PROPOSED SUBSURFACE WASTE DISPOSAL SYSTEM DETAIL SHEET

SUBDIVISION Stone Cross

LOT 48

Stonecross Lot 48

Lot 48 Stone Cross

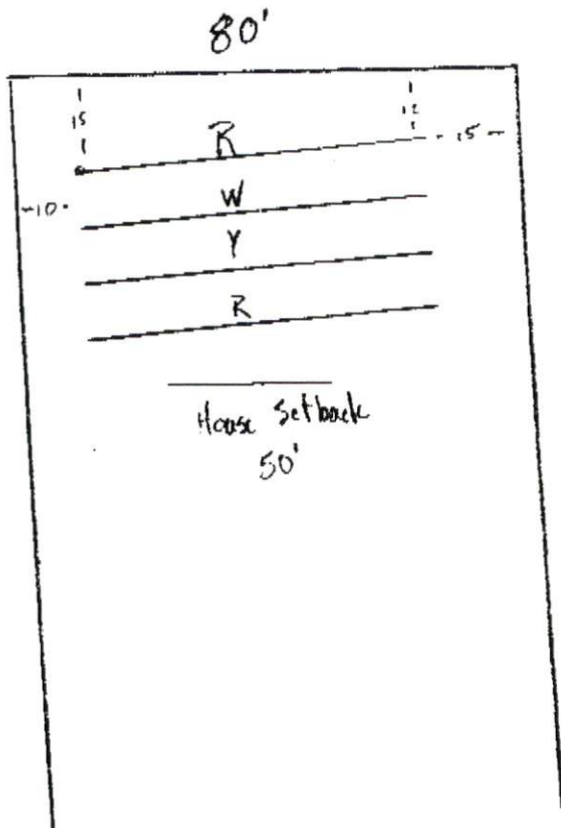
- MOVE HOUSE TO 50' FROM FRONT PL
- 15' DRIVE ON LEFT SIDE OF HOUSE (FACING HOUSE)
- IF FRONT ENTRANCE GARAGE HOUSE MUST MOVE BACK FURTHER TO ACCOMADATE DRING

Proposed Septic

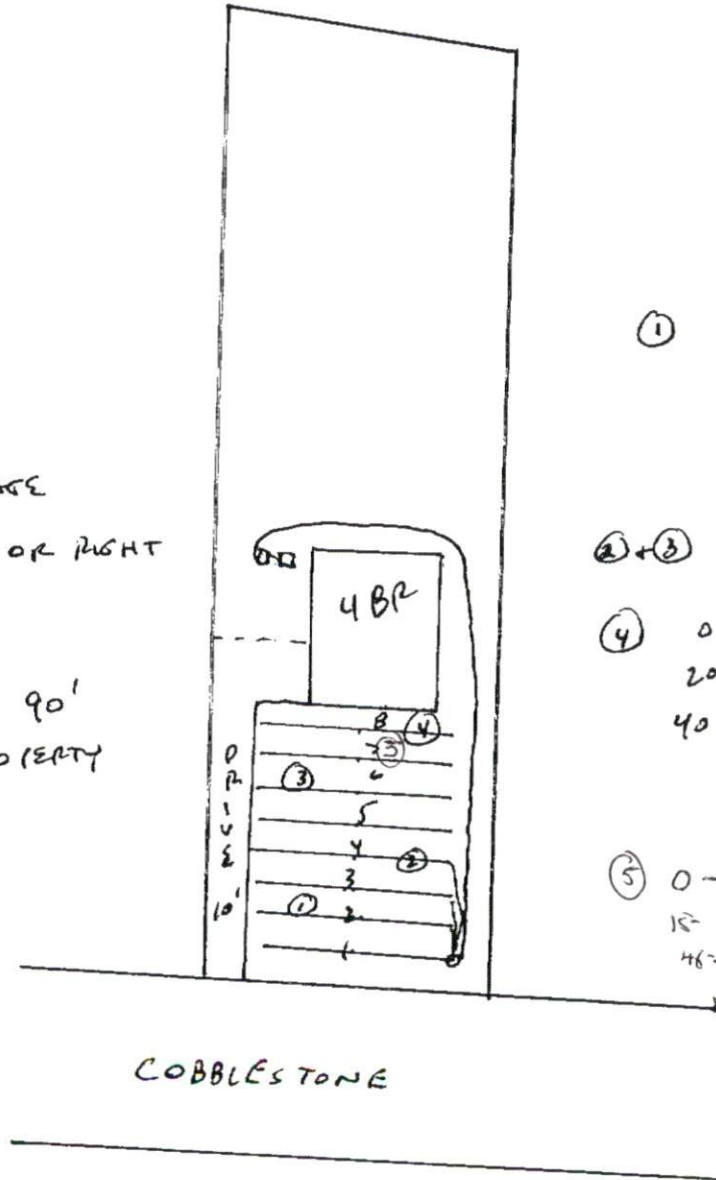
- * SIDE ENTRY GARAGE
- * DRIVE ON LEFT OR RIGHT PROP LINE
- * HOUSE SETBACK 90' FROM FRONT PROPERTY LINE
